2.0 SITE CHARACTERISTICS

The principal purpose of this chapter of the SHINE Medical Technologies, LLC (SHINE, the applicant) operating license application safety evaluation report (SER) is to discuss whether the SHINE site is suitable for constructing and operating the SHINE facility.

Figure 2.4.5-1: Comparison of SSE (yellow) with uniform hazard spectra for SDC-3 and SDC-4 facilities using site-specific subsurface information.

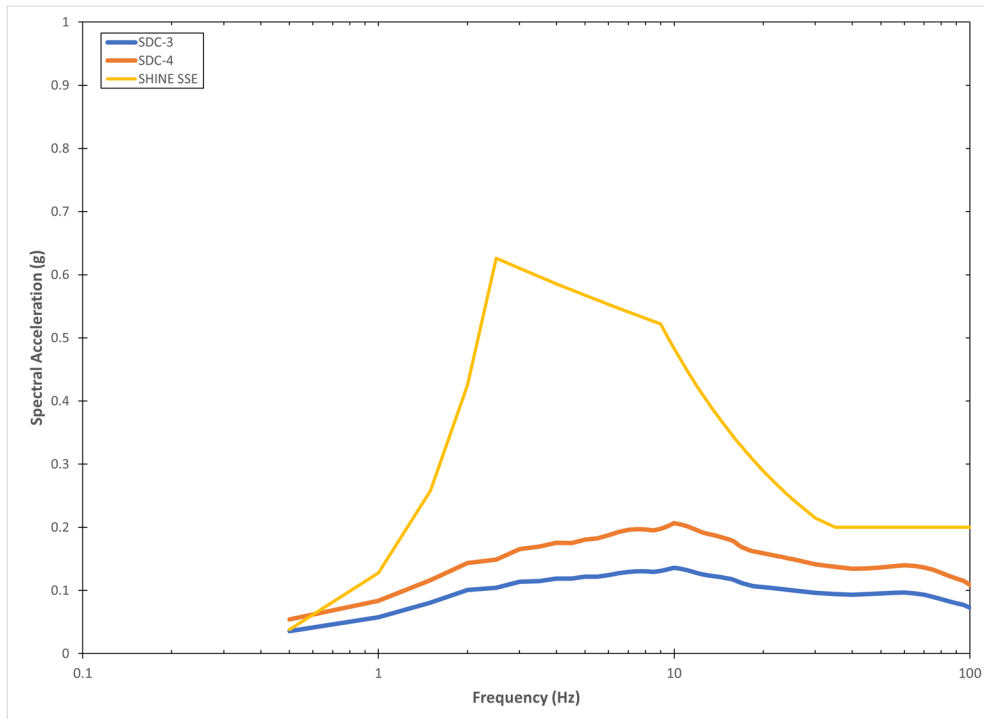
In addition to reviewing the application and the USGS results, the NRC staff performed a confirmatory PSHA that incorporates at-site information about the subsurface geology to develop uniform hazard spectra at the surface for Seismic Design Classification 3 and 4 (SDC-3 and SDC-4) facilities as defined in ANSI/ANS-2.26-2004, “Categorization of Nuclear Facility Structures, Systems, and Components for Seismic Design,” and computed following guidance in ASCE/SEI 43-05, “Seismic Design Criteria for Structures, Systems, and Components in Nuclear Facilities.” The staff used the seismic source model described in NUREG-2115, the ground motion model described in “EPRI (2004, 2006) Ground-Motion Model Review Project,” 2013, and the site-specific dynamic properties described by the applicant in its Preliminary Geotechnical Engineering Report dated August 3, 2012 (ML13309B618). The staff’s results, presented in figure 2.4.5-1, show that for an SDC-4 facility, the SSE envelopes the site-specific hazard at all frequencies greater than 0.6 hertz with significant margin. Greater margin is demonstrated for an SDC-3 facility.
